# **MPCP End-of-Grant Check**

Jeff Mandin - PMC-Sierra  
802.3av TF – New Orleans  
January 2009

## Option #2: Changes to Fig 77-14

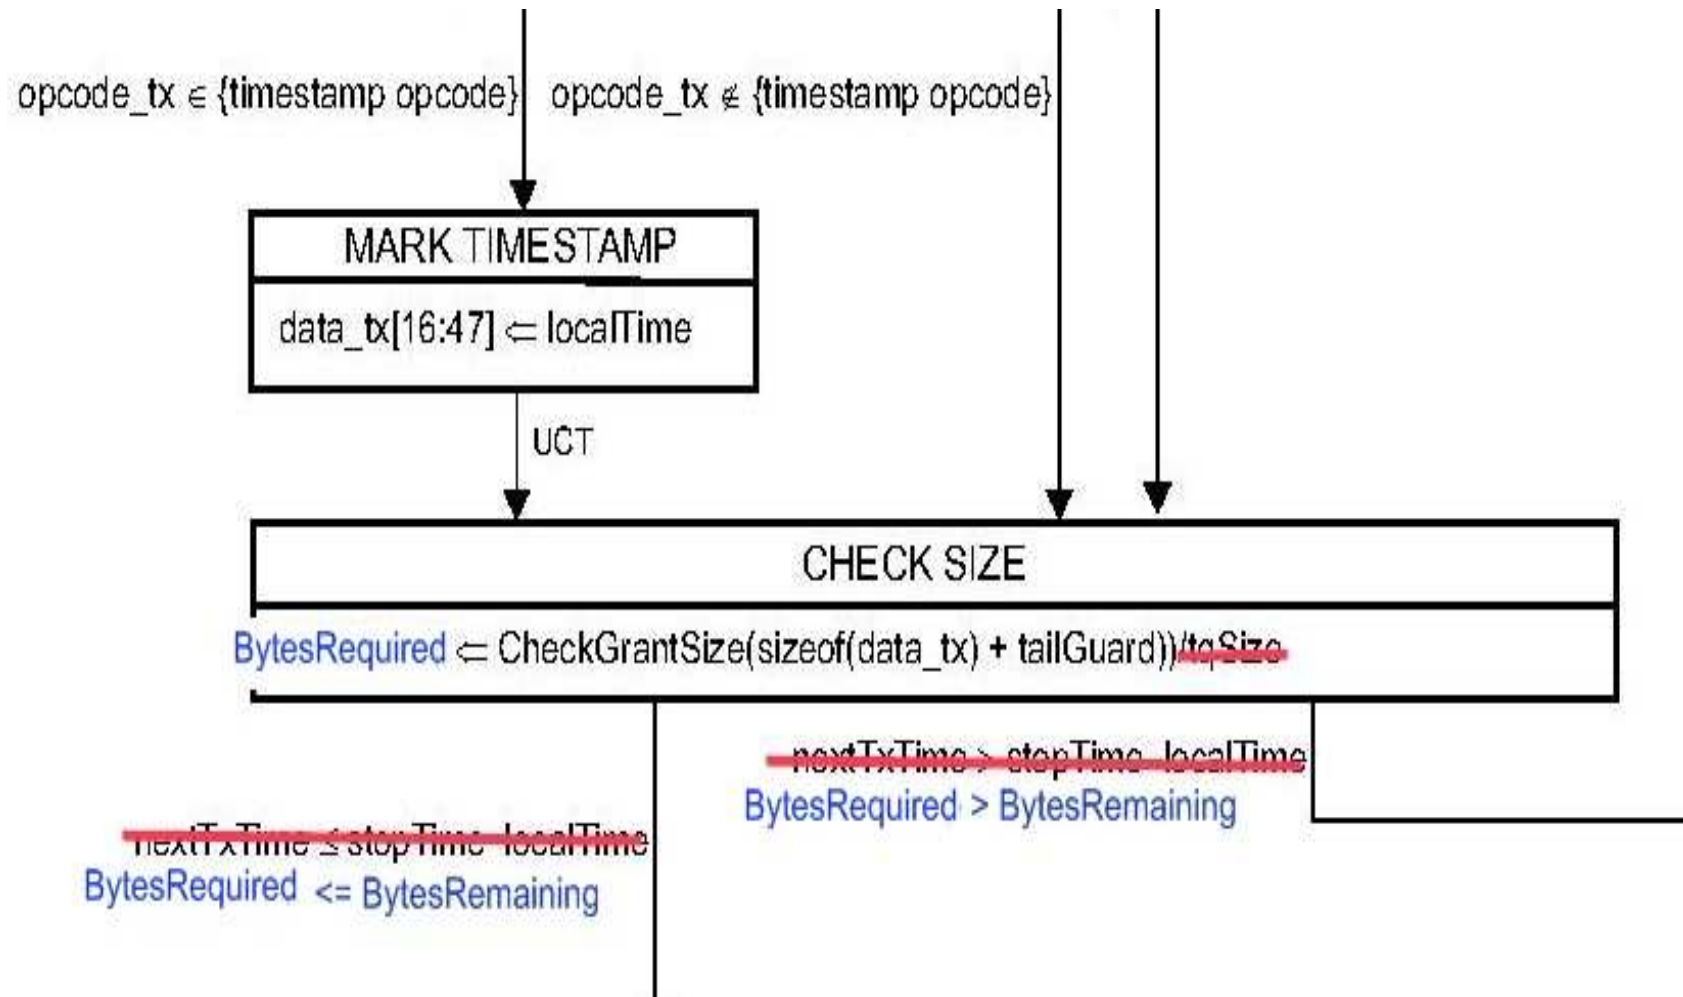
- Current behaviour in ONU Control Mux (figure 77-14)
  - a) Determine the number of bytes needed for transmission of the next frame
  - b) Convert to TQ by rounding **down**

- Problem: This permits transmission of a frame which will continue transmitting after StopTime (by up to 1 TQ)

- Option #1 prevents transmission past ***stopTime***
- But very cumbersome to do calculations on codewords, convert to bytes, and compare in TQ
- Better solution is to do the entire calculation in bytes:
  - Two additional variables are needed
  - But resulting calculations are much simpler

- a) Globally replace “NextTxTime” with “BytesRequired”
- b) In “BytesRequired” definition: Change “measured in units of time\_quanta” to “measured in units of bytes”
- c) Add the following definitions:

### **ByteTimeOffset:**

TYPE: 8 bit unsigned

- This variable denotes the offset (in octet times) of the current actual time from the **localtime** variable (which maintains the current time in units of time quanta). This variable enables calculations which require granularity more precise than a time quantum.

### **BytesRemaining:**

TYPE: 32 bit unsigned

This variable is an alias for the expression  $((\text{stopTime} - \text{localTime}) \times \text{tqSize}) - \text{ByteTimeOffset}$ . It denotes the number of bytes that can be transmitted between the current time and the end of the grant.
